**TECHNICAL MEMORANDUM**

TO: Dr. Robert Leidy, U.S. Environmental Protection Agency (EPA) Region 9

FROM: Dr. Mathias Kondolf, consulting fluvial geomorphologist, Berkeley, California, and James Ashby, PG Environmental, LLC, Golden, Colorado

SUBJECT: Conceptual Design for Sonoita Creek, AZ, Technical Review Support (Order Number EP-G149-00241)

Figure 2a. Hydrologic soil group map and color-coded ratings for Sonoita Creek area (see next page for map legend).

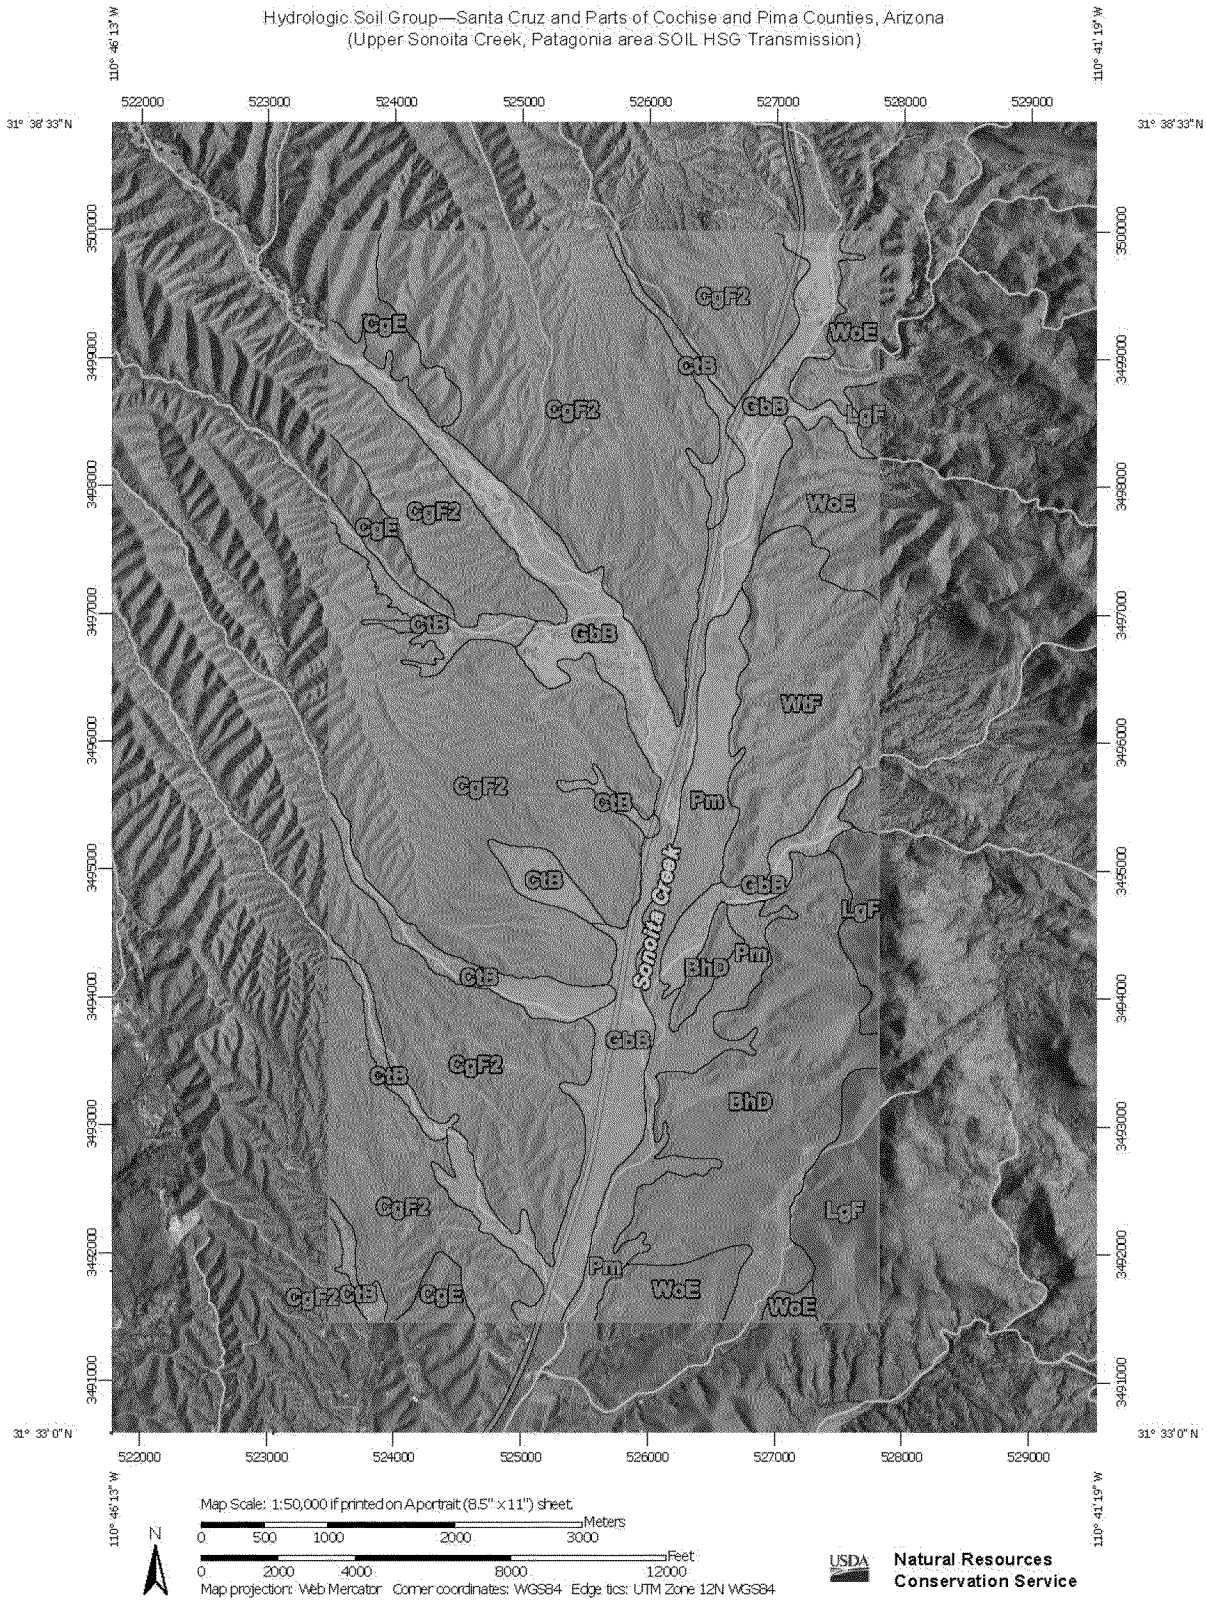
3) **The proposed constructed channels will likely not sustain flow in the specific soil types within the project reach.** The Sonoita Creek valley bottom consists primarily of alluvial deposits. In terms of mapped soil units, it is dominated by Grabe-Comoro complex (GbB) soils of gravelly sandy loam to sandy loam composition, that receive a hydrologic soil group classification (HSG) of Group A (refer to Figure 2a and 2b). Group A soils are characterized by high infiltration rates, low runoff potential, and a high rate of water transmission. The Sonoita Creek floodplain also has a lesser percentage of Pima soils (Pm), a clay loam that receives a HSG classification of Group C. Group C soils are characterized by slow infiltration rates and slow water transmission.

Transmission losses due to infiltration into the bed and banks are high in semiarid ephemeral streams, and multiple researchers have demonstrated that except during the highest flows, there is significant loss of in-stream flow due to seepage as the flow proceeds downstream in alluvial valleys (Levick, et al. 2008). The WET report (p.12) notes that transmission losses for streams like Sonoita Creek have been reported as high as 17-29%. Approximately half of the constructed pilot channels as proposed in the plan would be excavated into the highly permeable Grabe-Comoro complex soils, resulting in high transmission losses. Any portion of the flow that entered the newly constructed channels during low to moderate flow rate events, such as those that occur at a high frequency annual scale, would likely not be sustained, and likely not return to the main Sonoita Creek channel. Sediment drops out of suspension as infiltration occurs and flow drops in velocity, depositing new material in the channel. Resulting aggradation may fill the newly constructed channels, further restricting the ability of flows to be diverted and for any diverted flow to successfully return to the main Sonoita Creek channel, particularly at the downstream reaches of constructed channels. Continued aggradation in the constructed channel could eventually create an abandoned, non-functional channel. The overall result would be a loss of habitat in the main channel of Sonoita Creek and a failure to create new habitat in the constructed channels, therefore failing to meet the stated goals of the proposed design in the WET report.
